**DRAINAGE REPORT
FOR**

Carpenter's Training Center

Prepared by:

**Tierra West, LLC
5571 Midway Park Place NE
Albuquerque, New Mexico 87109**

ENGINEER'S SEAL	CARPENTERS CENTER 3900 PAN AMERICAN FREEWAY
DRAWN BY BUT	DATE 01/21/08
	24026 BASIN MAP
	SHEET # C-1
	TERRA WEST, LLC 5371 MIDWAY PARK PLACE NE ALBUQUERQUE, NM 87109 (505)858-3100
	RONALD R. BOHANNAN P.E. #71668
	JOB # 24026

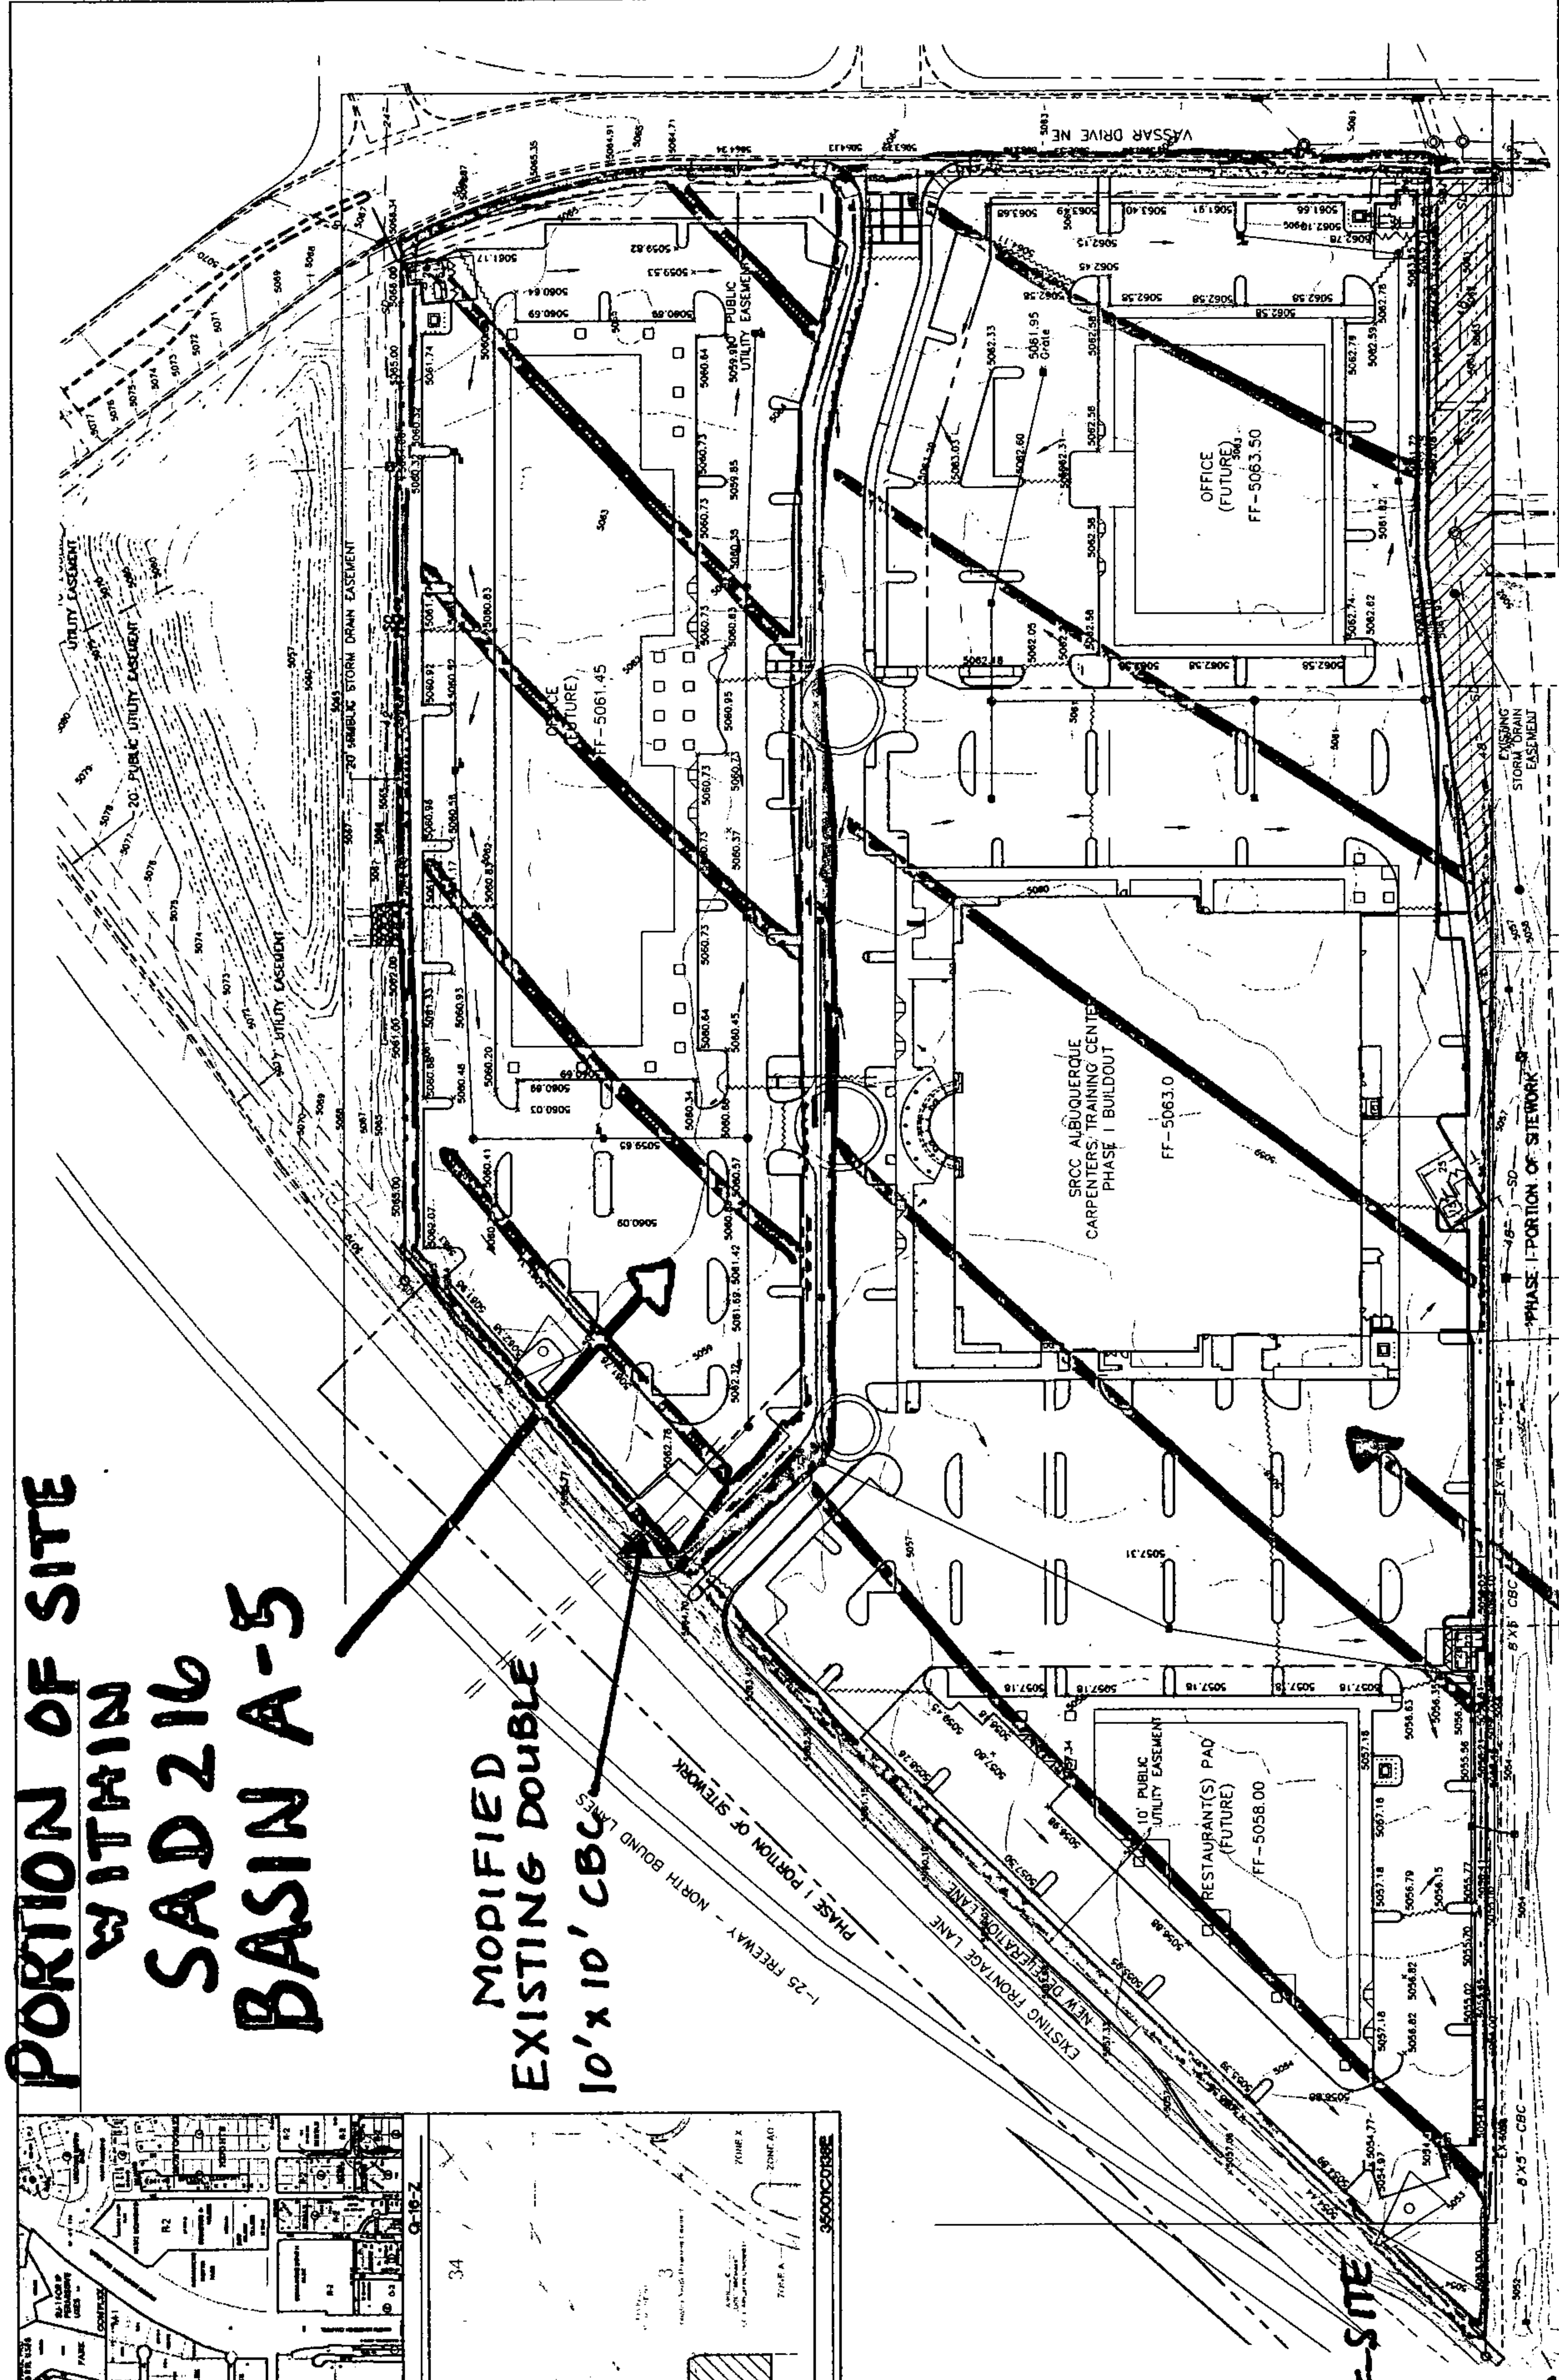
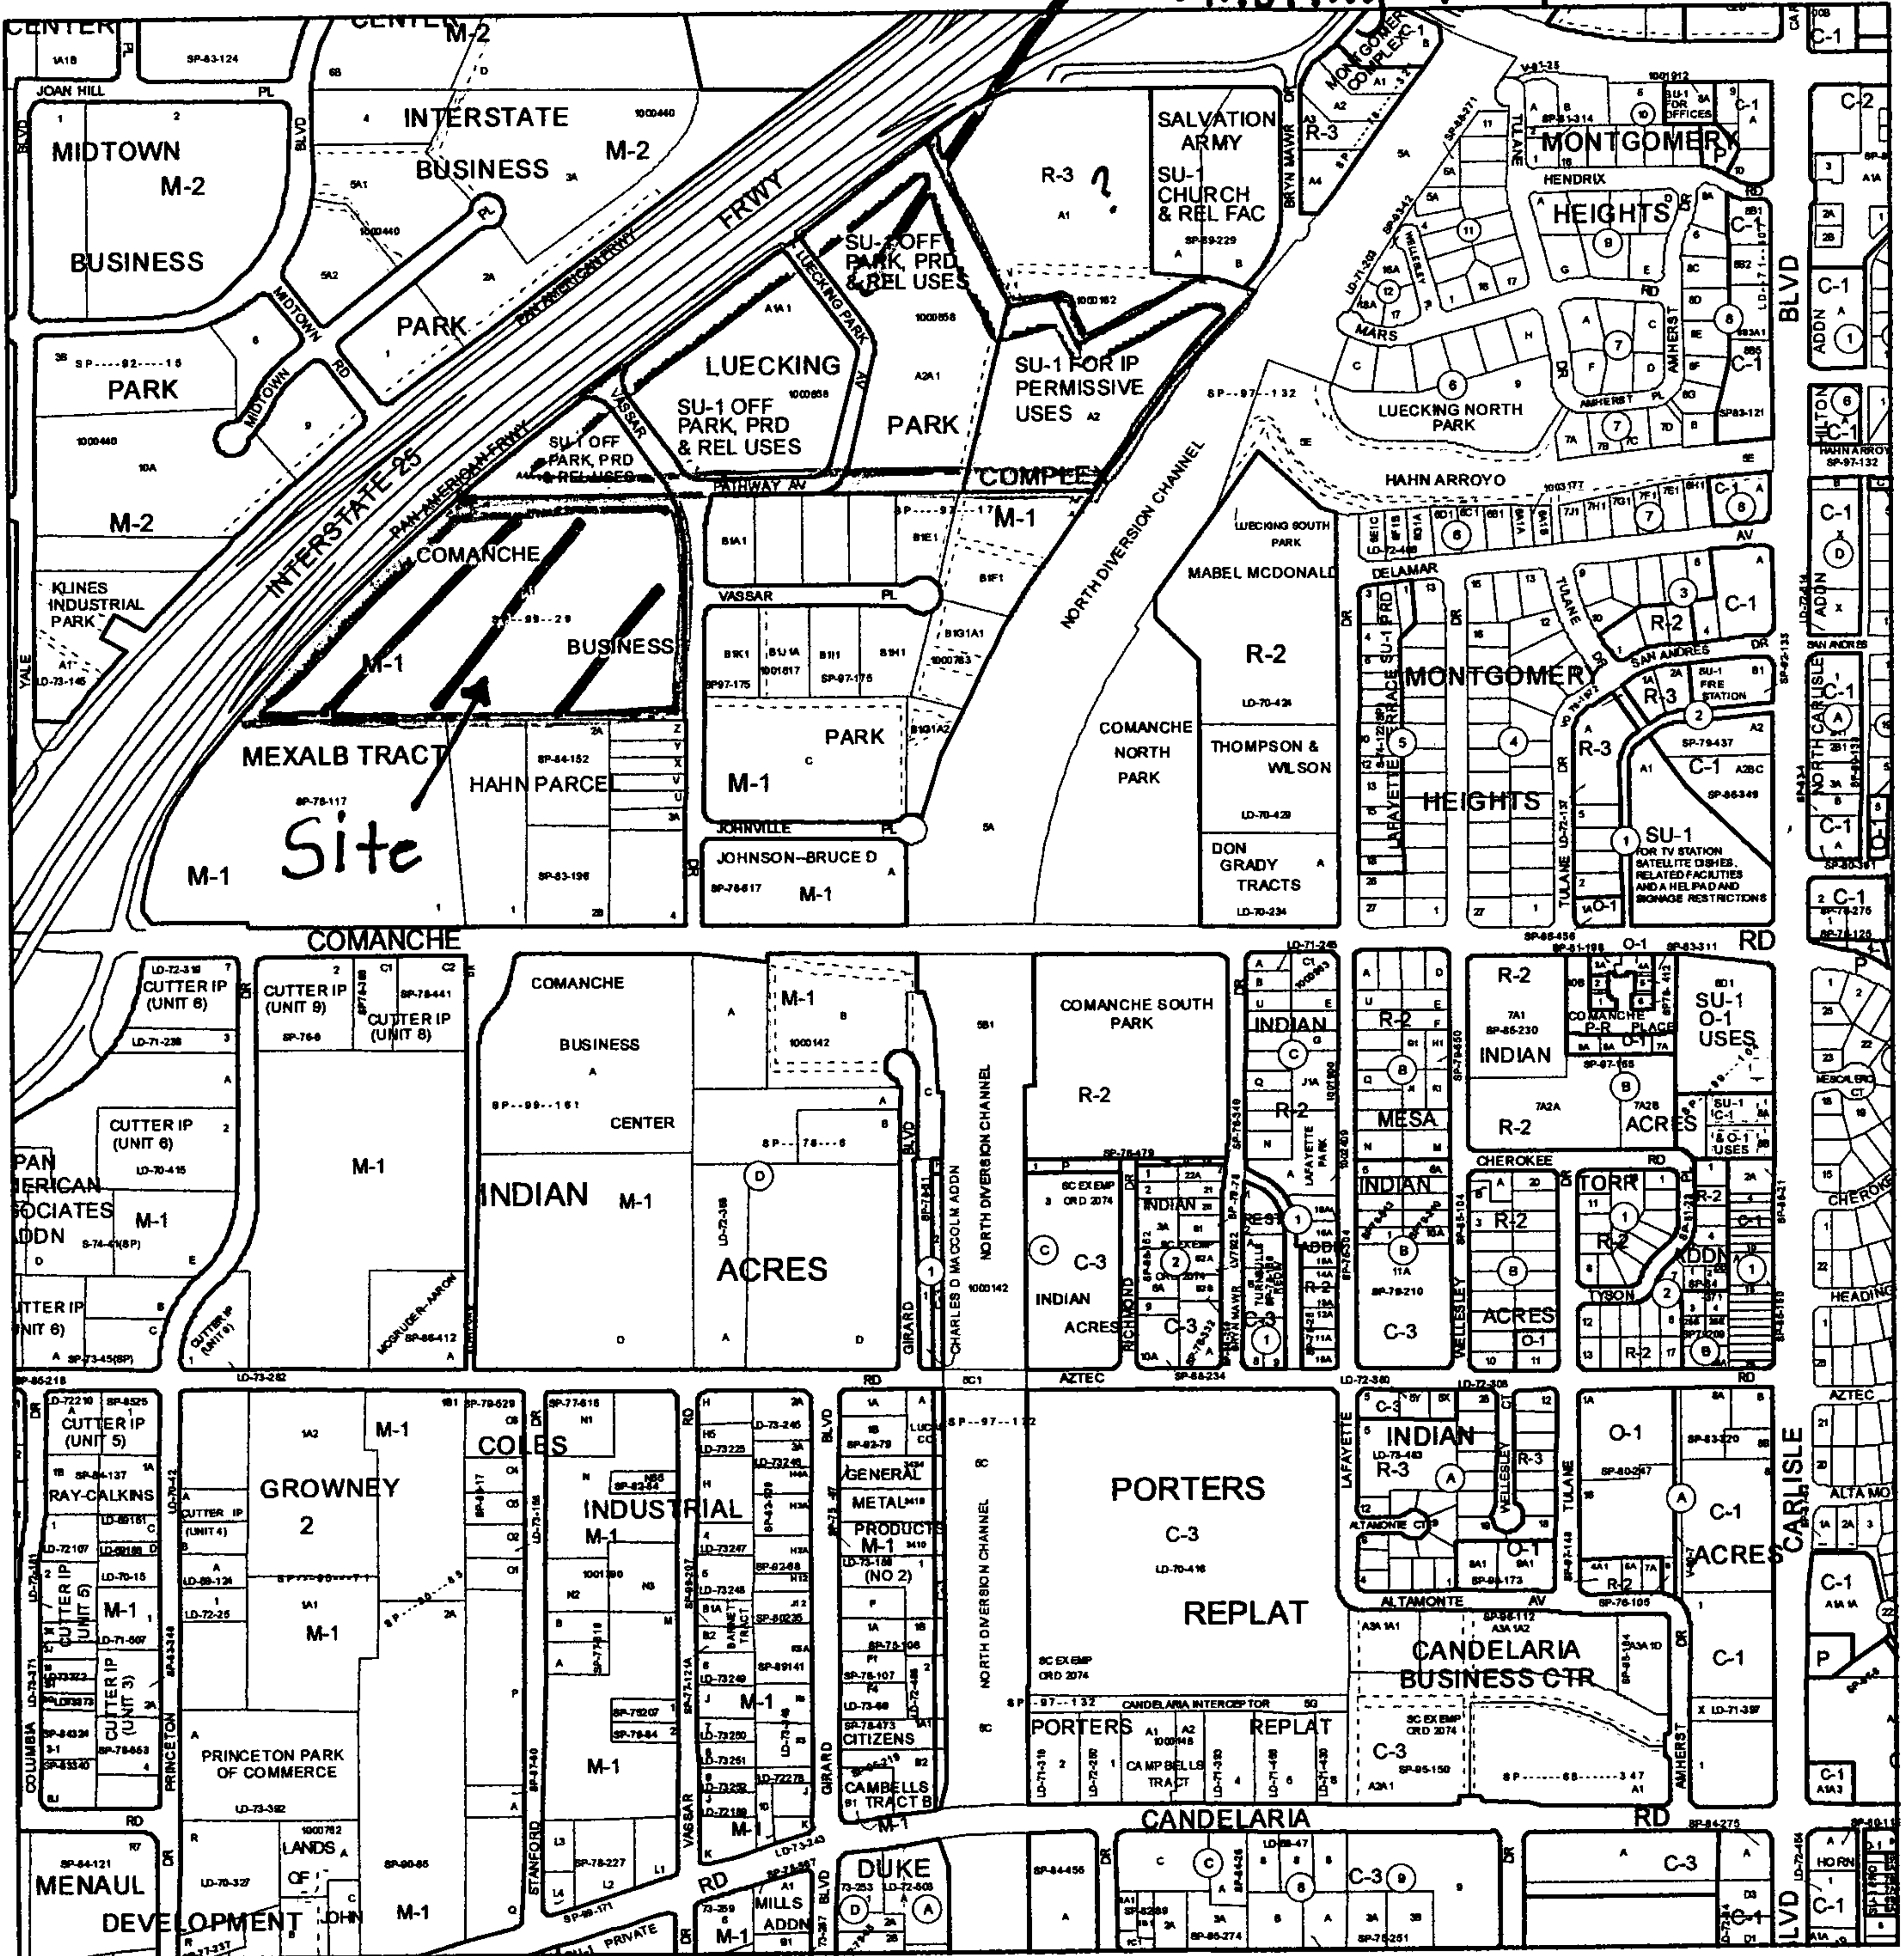
- Land treatments for some of the basins are suspect. For instance, basins 2, 6, 13 and 14 appear to be closer to 100% impervious, yet the spreadsheet shows all basins at 80% "D" and the AHYMO uses 15% "D" and 48% "A". This will have a big impact on the water surface in the above channel. Please recheck and revise accordingly.

3. Land treatment types for some of the basins are suspect. For instance basins 2, 11 and 14 appear to be closer to 100% impervious, yet the spreadsheet shows all basins 80% D and the AHYMO uses 15% "D" and 48% "A". This will have a big impact on the water surface in the above channel. Please recheck and revise accordingly.

The land treatment types for all basins were revised. The discharge for the site did increase slightly after the land treatment types were changed. The AHYMO data, Storm CAD profiles, drop inlet calculations, and pipe capacity table were revised to reflect the correct information. The pond will need to be modified in order to accept the discharge and allow for 1' of freeboard as required. The modification will include regrading the pond to increase its capacity. The proposed contours are shown on the revised plan.
